# THE GORDON BUILDING

**PROJECT:**  
Building Shell Eart  
Repair and Restic  
for Historic  
Gordon Building  
1130 First Street Napa,  
CA 94559  
APN: 003-166-004

## PROJECT DESCRIPTION FOR MILLS ACT APPLICATION FOR THE GORDON BUILDING AT 1130 FIRST STREET, NAPA

## Historic Preservation Certification Application

**A MEZZANINE FLOOR RESTORATION PLAN: REPAIR AND IMPROVEMENTS**

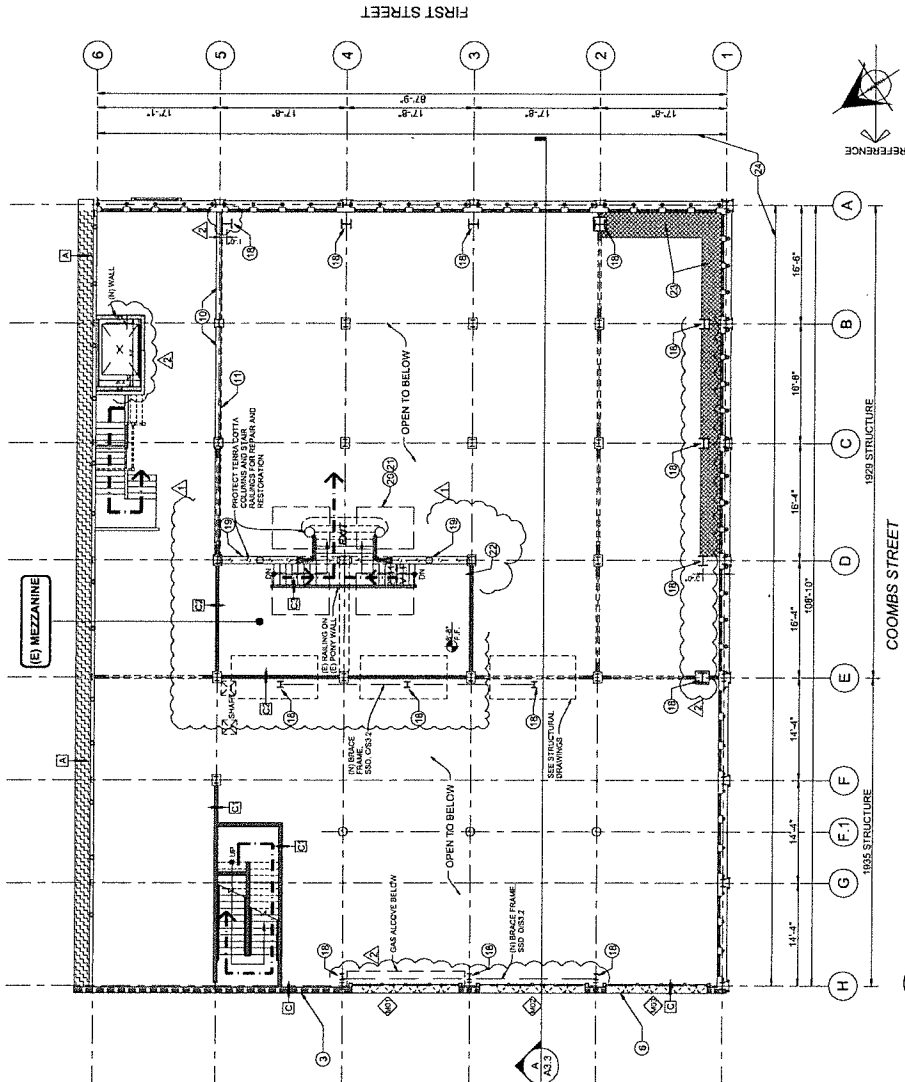
**Mezzanine and ornamental stair:**

The current proposal abandons the mezzanine in place due to the cost of making the mezzanine accessible. The ornamental stair is retained with barriers provided at the top. The floor/ceiling assembly, walls and partitions at the mezzanine are removed, and a soffit is created around the perimeter to reference the former ceiling and floor planes. The ornamental plaster molding proposed to be repaired at the mezzanine ceiling level can then be seen from the first floor. The inclusion of the light well square footage at the second floor removes the natural light source from the extant skylight, which is an additional defining feature of the mezzanine space.

Based on the submitted information, the mezzanine must remain intact even if accessibility is not provided. Existing character-defining features and fabric

characterizing the mezzanine must remain in place. The skylight opening must remain but artificial light may replace the natural light lost.

The disuse of the mezzanine level does not justify the removal of original fabric or the loss of the character defining space and does not meet Standard 2. **See Conditions.**

1. The second floor corridor must remain intact. Retain and repair the second floor corridor including all doors, trim, borrowed light window openings and other character-defining features.
2. All character-defining features of the mezzanine must remain intact such as the floor, walls, plaster cornice and ceiling plane including a recessed skylight. Provide a compatible light source for the ceiling recess.
3. Provide a more compatible structural scheme that reduces visual impact to the ground floor, and conceals the visibility of the moment frame to the extent possible.
4. Retain and repair wing walls at column line 3 at the first floor.
5. Replace in kind all wall finishes removed for structural inspection for walls to remain.
